Zoning Staff Report

Date: August 8, 2023 Case Number: ZC-23-087 Council District: 11

Zoning Map Amendment & Site Plan

Proposed Use: Multifamily Apartment Complex

PROJECT DATA

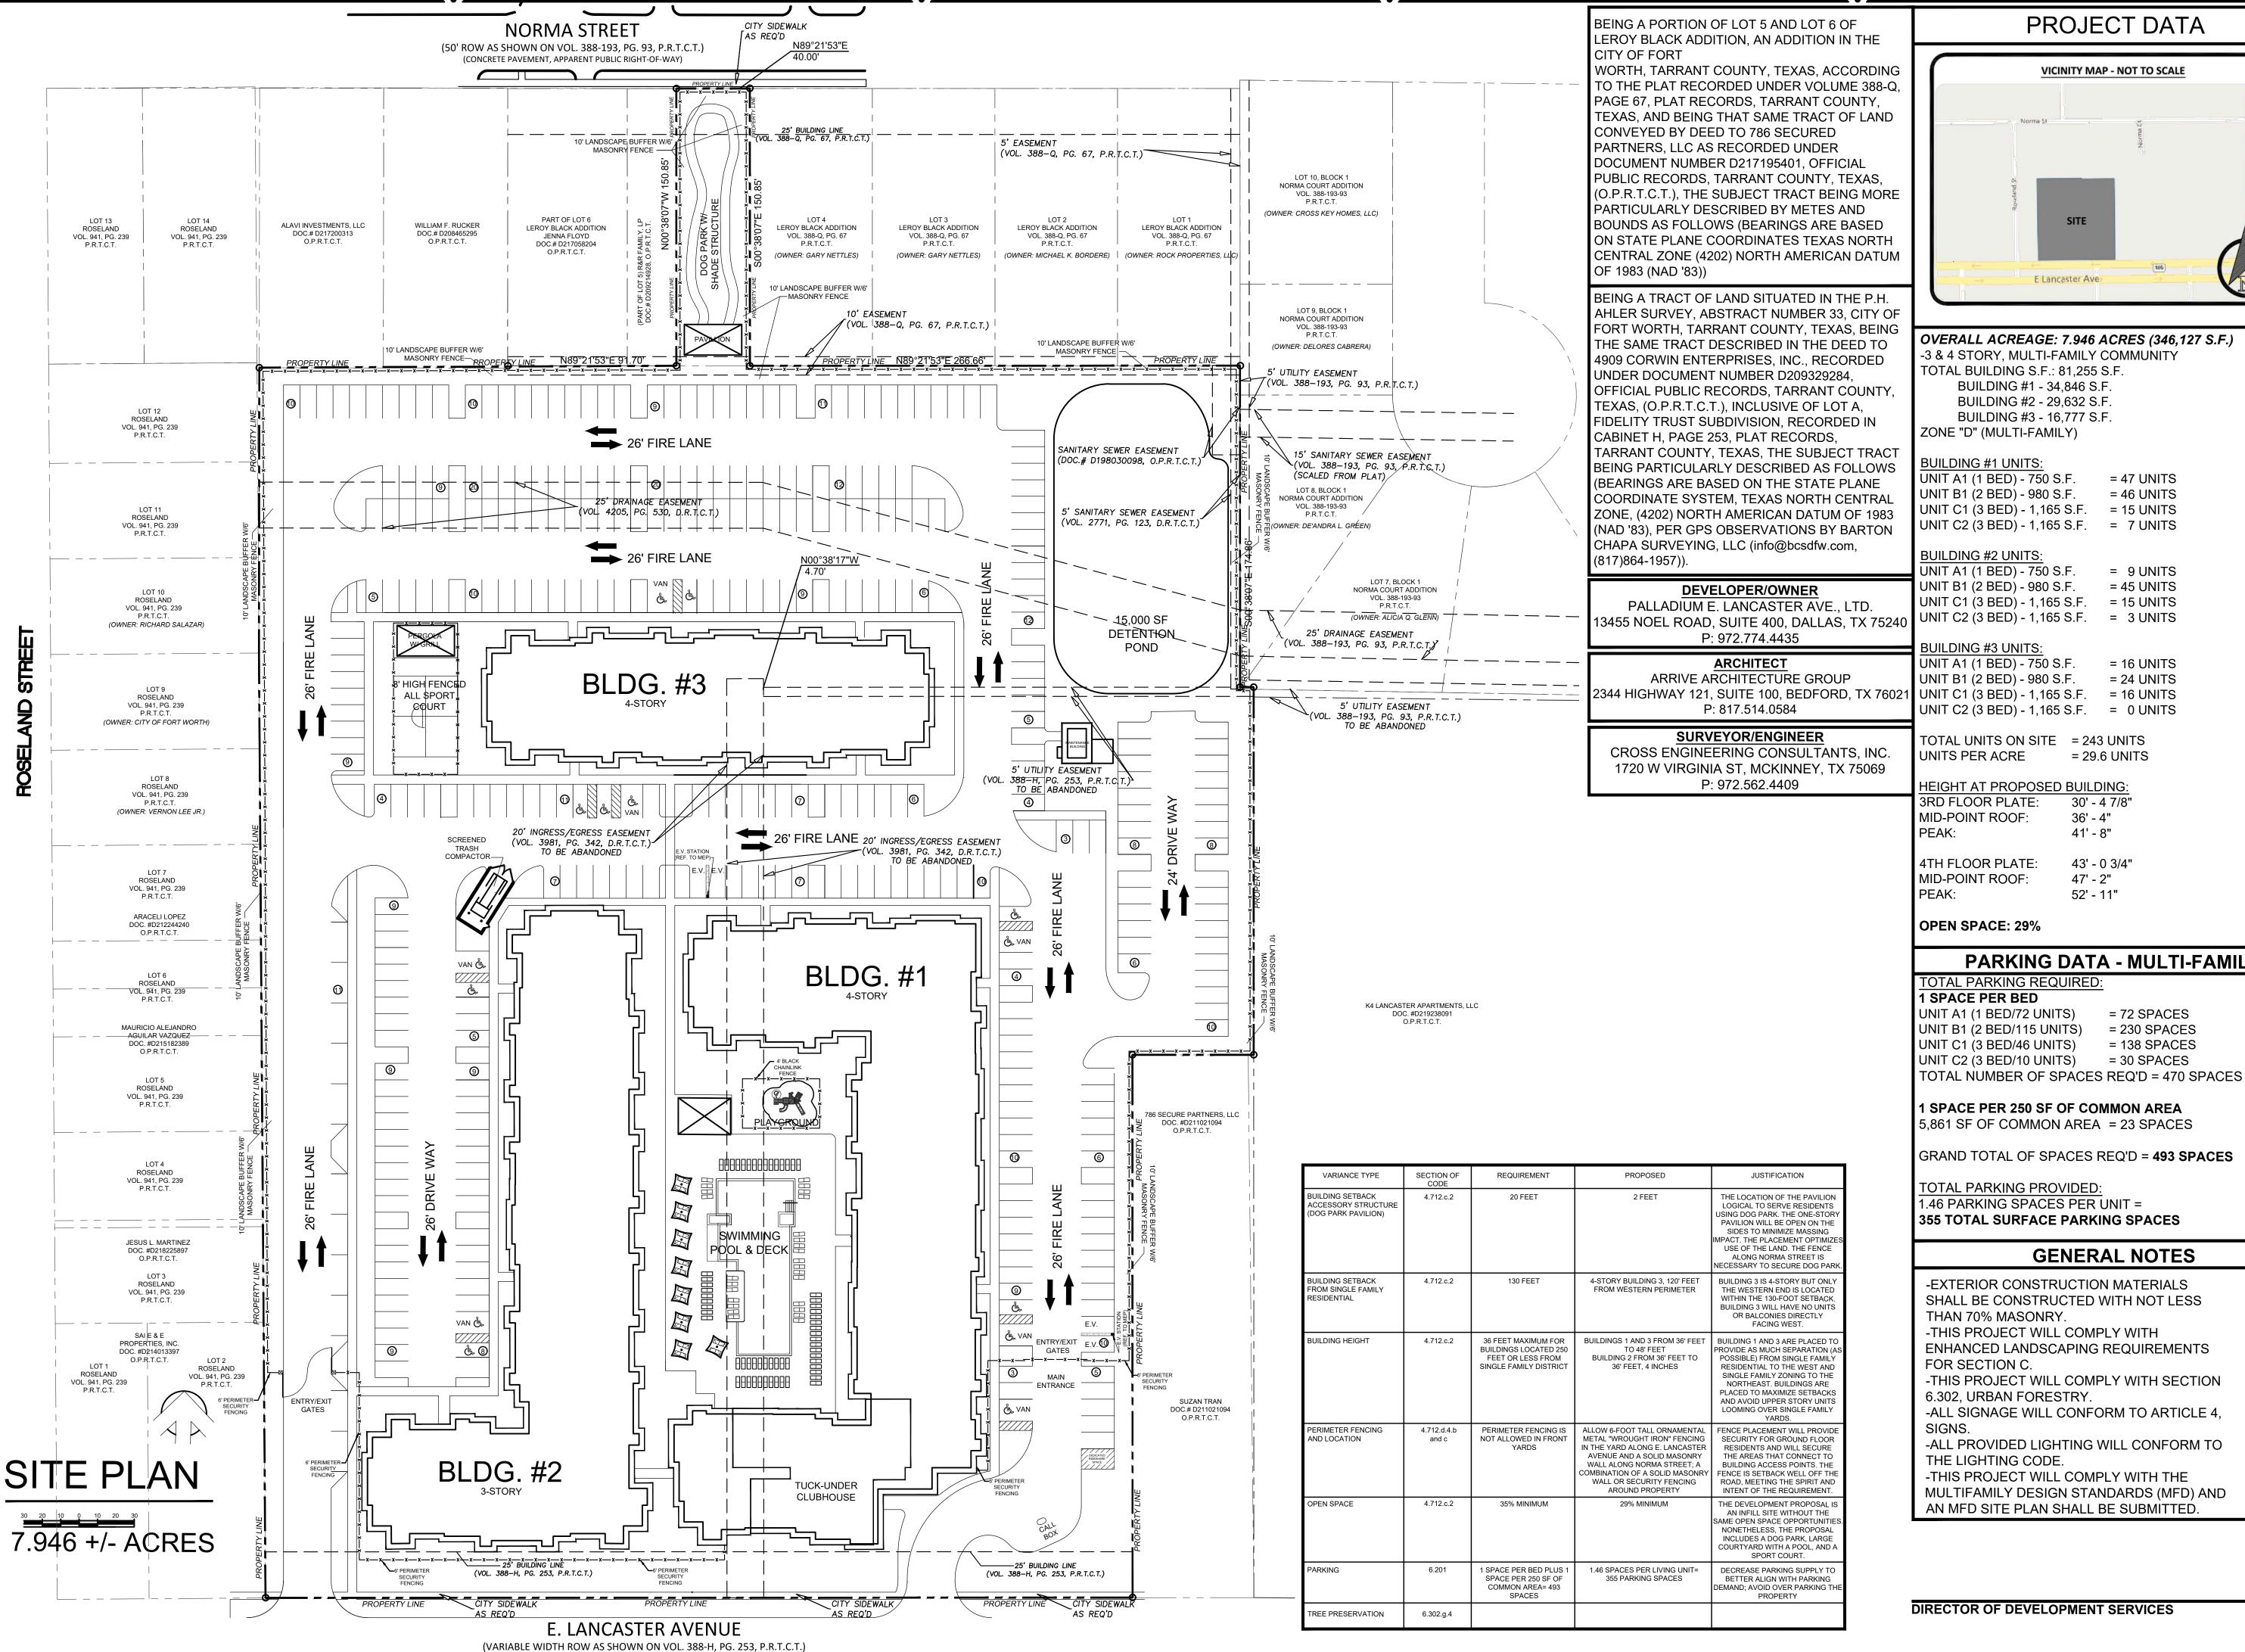
- Staff has concerns with the dog park location and the associated setback. I believe this is going to create major concerns with the adjoining residential.
- Has your team considered reducing the density to align with the small area designated for Medium Density on the land Use Plan?
- Please start you outreach with adjoining neighbors, Neighborhood Associations and the Councilman for this district. I have provided this information below:

Fire lane specifications can be found at IFC 2021/CFW Adopted Amendments Ordinance #25388-03-2022 Section 503

Less than or equal 600 ft. (300 ft. radius) of space between hydrants along a direct horizontal line.

Less than or equal 500 ft. hose lay distance to all points of building.

FDC's for sprinkler and standpipe systems shall be located within 50 ft. of a dedicated street or fire apparatus access road and shall be within 150 ft. hose lay distance of the nearest fire hydrant. Each building shall be equipped with its own FDC, unless otherwise approved by the fire code official.
